SUBJECT: REQUEST FOR ADDITIONAL INFORMATION FOR THE REVIEW OF THE  
MODEL NO. DN-30 PACKAGE

Docket No. 71-9362  
EPID No. L-2018-NEW-0003

**Request for Additional Information**  
**DAHER NUCLEAR TECHNOLOGIES GmbH**  
**Docket No. 71-9362**  
**Model No. DN-30 Package**

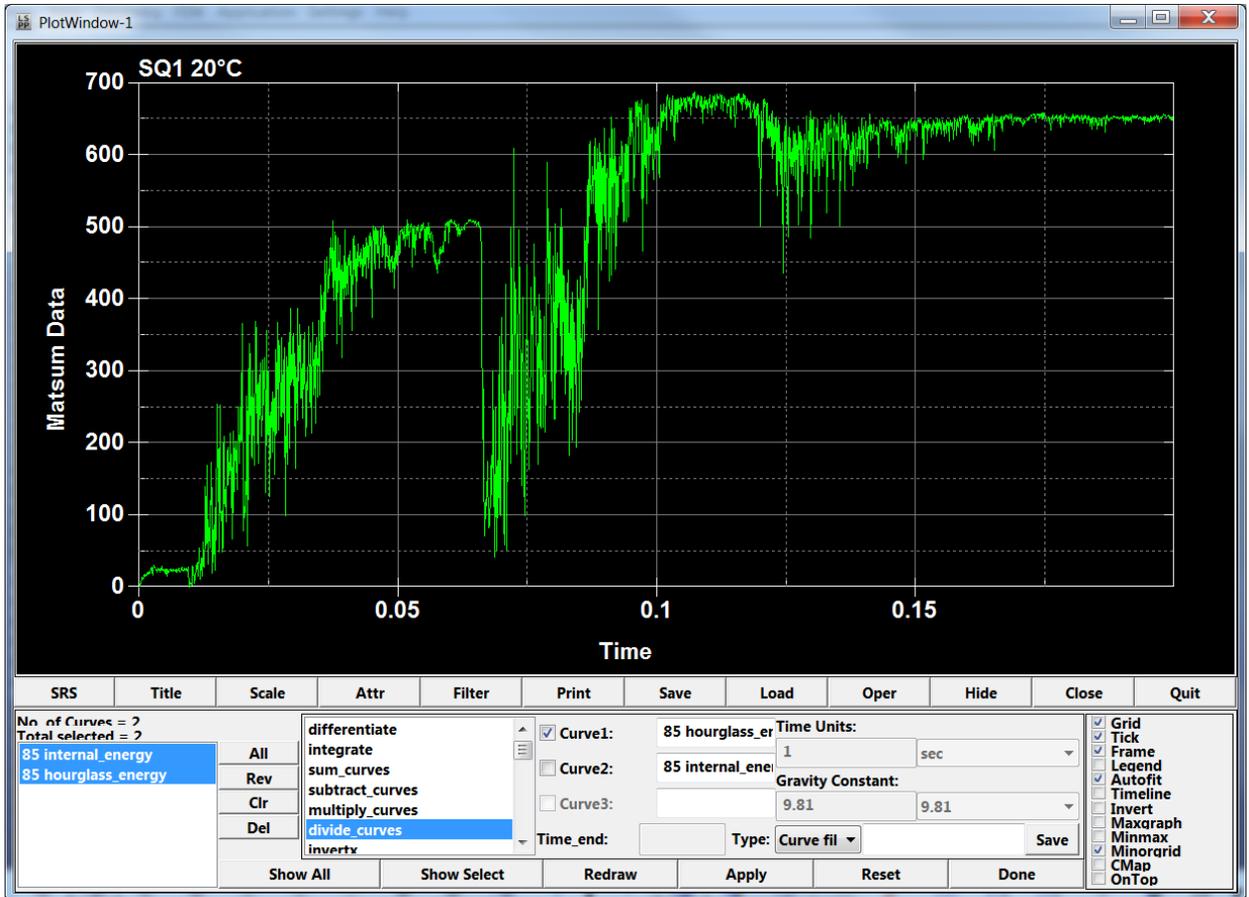
- 2-1 Clarify and justify the assumptions made in the characterization of UF<sub>6</sub> contents with respect to LS-DYNA hypothetical accident conditions (HAC) drop simulations of the DN30 Package.

For HAC drops simulated in LS-DYNA, the applicant assumed that the UF<sub>6</sub> in the 30B cylinder remains a single solid piece. In addition, the material properties assigned to the contents are not those of normal concrete but are similar to "reinforced" concrete; however, according to picture 4 of the drop test program (document 0023-BDI-2015-002), the contents are described as being partially loose and with large fissures.

- a) The assumption that the UF<sub>6</sub> material is always bonded to the 30B cylinder. If the contents are one solid piece and detach from the 30B cylinder during any of the simulated drops, it could cause internal damage to the 30B cylinder and/or valve plug. Drop simulations should be re-examined in this instance.

- b) The UF<sub>6</sub> material is modeled as one large piece during the drop simulations. Clarify if vibrations incident to transport could potentially “break up” or fracture the UF<sub>6</sub> material, prior to a drop. In such a case, large pieces of UF<sub>6</sub> should be modeled during drop simulations.
- c) The use of “reinforced” concrete material properties for the UF<sub>6</sub>. Large inelastic deformations can occur in the UF<sub>6</sub> material based on this material model, allowing energy to be absorbed into the UF<sub>6</sub> rather than the surrounding containment boundary and potentially imposing less structural demand on the containment boundary (30B cylinder). Assuming more realistic (i.e., more brittle) material properties for the UF<sub>6</sub> could potentially cause more damage to the containment boundary.

Confirm the modeling of the contents and update the LS-DYNA drop simulations as necessary.

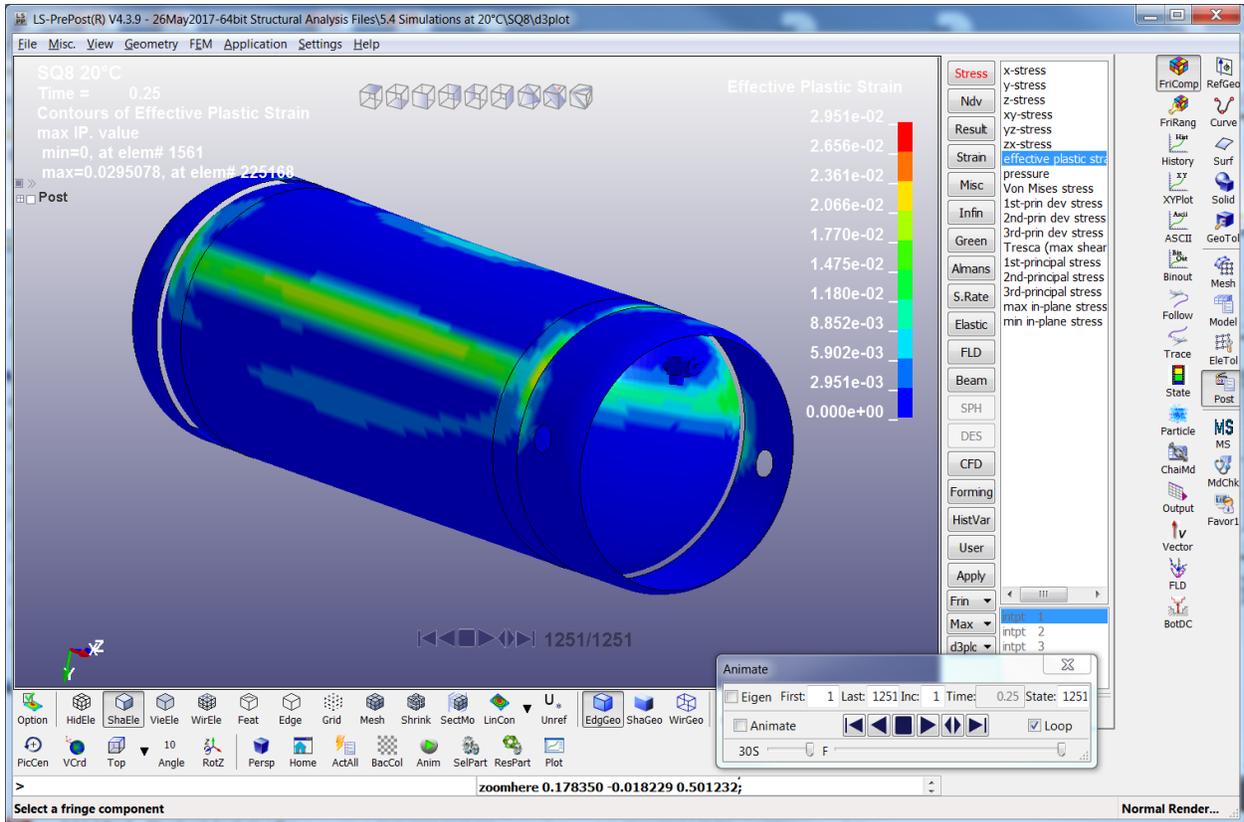
- 2-10 Justify the use of tied contacts in LS-DYNA drop simulations to represent welds in the package.

The image below displays the inelastic deformations observed in the 30B cylinder after Sequence 8 has terminated. The applicant states that a fine mesh would be required to model the welds between parts such as those in the 30B cylinder but would be too time consuming. Instead, tied contacts have been used. From the picture below, the canister appears to have inelastic deformations, in the main body of the cylinder, which do not carry at all into the adjoining/protruding flange which, if welded, should experience very similar inelastic demands where the 2 parts meet.

The parts appear to be too separated from each other and do not appear to be transmitting forces correctly. The valve at the end of the cylinder appears to be in a zone of inelastic deformation; yet, it is unclear how the valve behaves as a result. Staff is concerned that the containment boundary (valve) may not be free of inelastic deformation as desired. Similar behavior has been noted for the 30 B cylinder in other sequences.

The applicant shall verify that the tied contact assumption is valid when compared to welds that have been modeled as the rest of the 30B cylinder (with a mesh).
